**SUNDRY NOTICES AND REPORTS ON WELLS**  
*Do not use this form for proposals to drill or to re-enter an abandoned well. Use form 3160-3 (APD) for such proposals.*

**Plug and Abandonment Procedure**  
**for**  
**DJR Operating, LLC**  
**Bisti Gallup 22-15**  
**API # 30-045-34132**  
**SW/SE, Unit O, Sec. 22, T25N, R12W**  
**San Juan County, NM**

**BLM FLUID MINERALS  
Geologic Report**

**Attachment to notice of Intention to Abandon**

**Proposed Wellbore P&A Diagram**  
**DJR Operating, LLC**  
**Bisti Gallup 22-15**  
 API # 30-045-34132  
 SW/SE, Unit O, Sec 22, T25N, R12W  
 San Juan County, NM

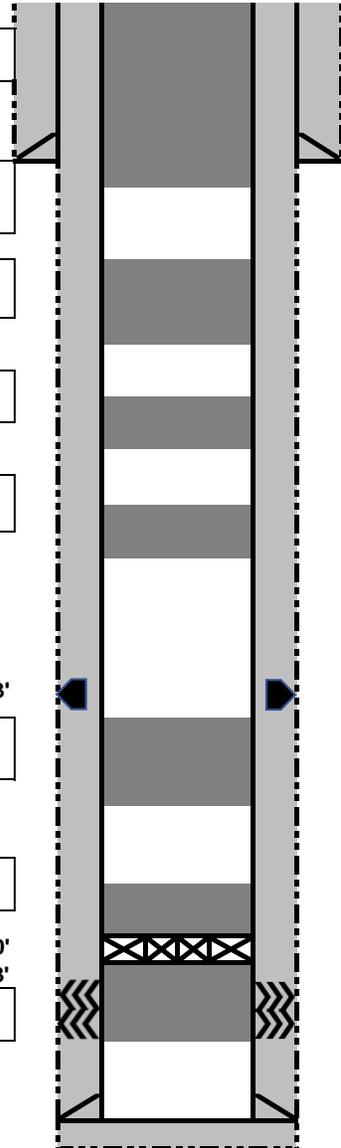
- Please ensure that the tops of the Pictured Cliffs, and Fruitland formations, as well as the entire Ojo Alamo aquifer, identified in this report, are isolated by proper placement of cement plugs. This will protect the freshwater sands in this well bore.

- The top of the Ojo Alamo formations is behind the surface casing and its depth is estimated. The proposed plugging plan will adequately protect the freshwater sands in these formations.

Please note that the BLM geologist's pick for the Cliff House formation varies from the operator's pick.
